573.6 Defect Information Report

MY 2008 Victory Vision motorcycles.

SUBJECT: Ignition Switch Improperly Assembled

IGNITION SWITCH BASE RETAINER KIT INSTRUCTIONS

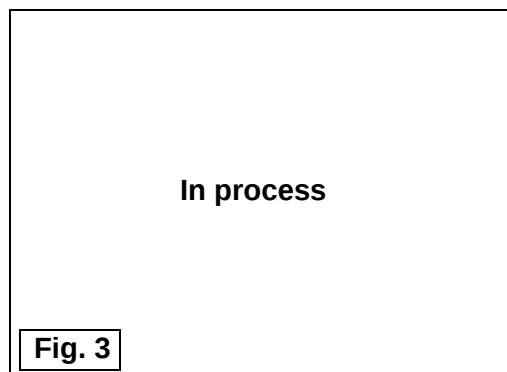
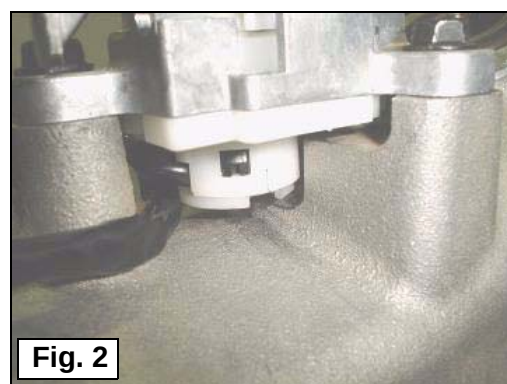
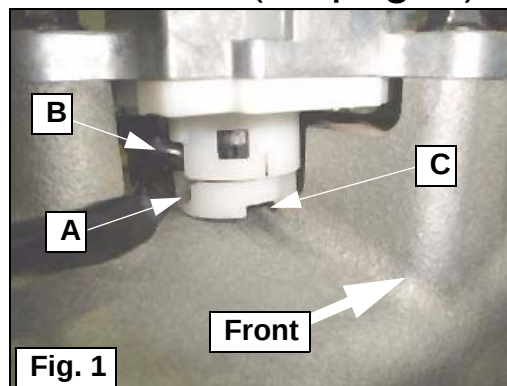
Overview: The retainer ring and shim can be installed with the console and all body work in place. Some part were removed for clarity in the photos below. Work from a seated position on the motorcycle or straddle the seat so you can use your left and right hands under the console. The retainer must be oriented properly with the large single opening in the ring facing UP and positioned over the ignition switch wire harness (at rear side of switch). With retainer in position, the shim is guided from right to left through the two slots on the bottom side of the retainer, then pulled firmly from the left side until seated. The shim is left in place under the retainer after installation.

1. Be surew the area around the switch base is clear of any wiring. Working from the RIGHT side of the console, slide the retainer into position under the switch base with the large single slot (A) facing upward and rearward. Align the slot with the switch wire harness (B). (Fig. 1)

2. Reach in from the LEFT and RIGHT sides and rotate the insert slightly as needed until you feel the upper slot straddle the wire harness. The two slots (C) on the bottom side should now be centered on left and right sides of switch base. (Fig.1)

3. Lift the retainer ring slightly and hold it in position with your left hand from the left side.
4. With the shim positioned as shown in Fig. 3, (stop tab on right end is pointed upward) slide the thin end of the taper into the right side slot and push the tool through until the end comes out through the left side slot.

5. Reach in from the left side and grasp the thin tapered end of the tool firmly.
6. Pull the tool toward the left side until the end tab stops against the right side of the switch.

7. Trim the left side of the shim to remove any visible portions.
